### ARCHITECT'S SUPPLEMENTAL INSTRUCTIONS JONES GILLAM RENZ DOCUMENT JGR 710

PROJECT:	The Temple Elevator Rehabilitation Project Salina, KS	Report No.	Three (3)
OWNER:	Salina Innovation Foundation Mary Landes, Director 336 S. Santa Fe Ave Salina, KS 67401	Date	February 9, 2026
CONTRACTOR:	Ponton Construction 1325 Armory Rd. Salina KS 67401	Architect's Proj No.	25-3499
		Contract For:	General Construction Mechanical, Electrical

# ENGINEERING JUDGMENT FIRESTOP DETAIL

HILTI, Inc. Plano, Texas USA (800) 879-8000	Sheet 1 of 2	Drawing No. <b>710145a</b>
Designed by Hilti FPE Sydney Riopel	Scale 1/4" = 1"	
	Date Feb. 08, 2026

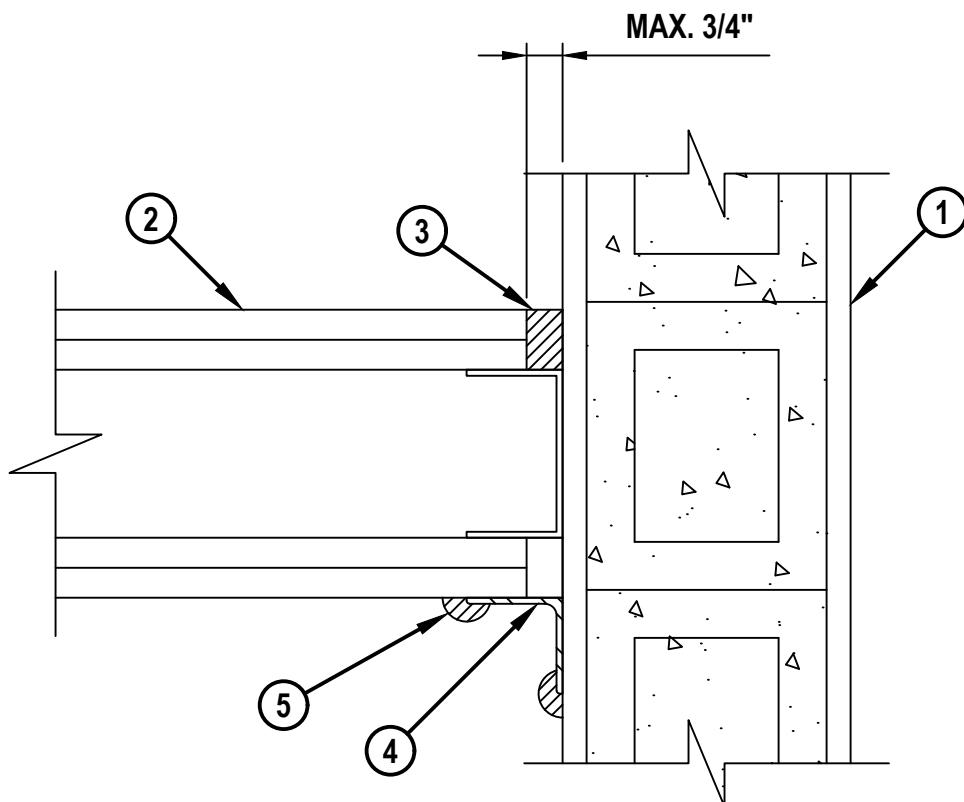
- 1) Contractor to make adjustments as needed and required per the modifications as indicated on attached drawings and in the below descriptions:
  - a. See attached details from Hilti.

**DUE TO THE PRESENCE OF AN UNPROTECTED STEEL MEMBER, THIS FIRESTOP DETAIL IS BASED UPON THE APPLICABLE TEST METHOD (LISTED BELOW) REQUIREMENTS FOR A MODIFIED F-RATING. THE MODIFIED F-RATING CRITERIA FOR THIS DETAIL SHALL BE SUCH THAT THE TEST SPECIMEN SHALL HAVE WITHSTOOD THE FIRE RESISTANCE TEST FOR THE PERIOD EQUAL TO THE RATING INDICATED ON THIS DETAIL BY PREVENTING FLAMING ON THE UNEXPOSED SIDE OF THE TEST SPECIMEN, BUT WITHOUT THE REQUIREMENT THAT THE TEST SPECIMEN REMAIN IN THE JOINT OPENING DURING THE HOSE STREAM TEST. IN ADDITION, TEMPERATURE CRITERIA OF THE APPLICABLE TEST METHOD ARE NOT EXPECTED TO EQUAL THE HOURLY DURATION OF THE F-RATING FOR THIS ASSEMBLY.**

1. PLASTER BLOCK WALL ASSEMBLY (MINIMUM 6" THICK) (2-HR. FIRE-RATING).
2. GYPSUM WALL ASSEMBLY (UL/cUL CLASSIFIED) (MIN. 3-1/2" WIDE STEEL STUDS) (2-HR. FIRE-RATING).
3. MINIMUM 1-1/4" DEPTH HILTI FS-ONE MAX INTUMESCENT FIRESTOP SEALANT.
4. SOLID STEEL ANGLES (MIN. 1/4" THICK) SIZED TO COMPLETELY COVER JOINT AND SECURELY ATTACHED PER ONSITE DESIGN ENGINEER'S SPECIFICATIONS.
5. MINIMUM 5/8" BEAD HILTI FS-ONE INTUMESCENT FIRESTOP SEALANT APPLIED AT GYPSUM/PLASTER AND GYPSUM/ANGLE INTERFACE AND TO COMPLETELY COVER EXPOSED EDGE OF GYPSUM.

1. MAXIMUM WIDTH OF JOINT = 3/4".
2. THIS SYSTEM IS DESIGNED AS A STATIC SYSTEM ONLY.
